Access Compliance Report Public Rights-of-Way (Pedestrian Signals)

Intersection ID: N/A	Main Street:	Cross Street: N/A	Location: N/A
ADA ID: 17844CD4F888	Signal Type: One Push Button-Non APS	Overall Compliance: No	Severity Score: BTN 1: N/A BTN 2: N/A No BTN: N/A
Codes/Mitigation Info/Possible Solution		Field Measurements/Component Compliance

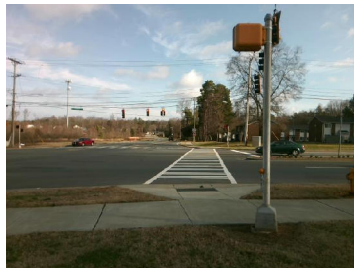
PROW/ADA: TMUTCD 4e.08, R404.7.2

N/A	B 1 Clear Xing Direction?	Yes	N/A	B 2 Clear Xing Direction?	N/A
	B 1 Crossing Direction	To NE		B 2 Crossing Direction	N/A
Yes	B 1 DistanceTo XWalk (in)	0.0	N/A	B 2 DistanceTo XWalk (in)	N/A
No	B 1 DistanceTo Curb (in)	158.0	N/A	B 2 DistanceTo Curb (in)	N/A
Yes	B 1 Diameter (in)	2.0	N/A	B 2 Diameter (in)	N/A

Possible Solutions: Replace Signal Push Button With APS Button on New Post. Remove & Relocate Sign.
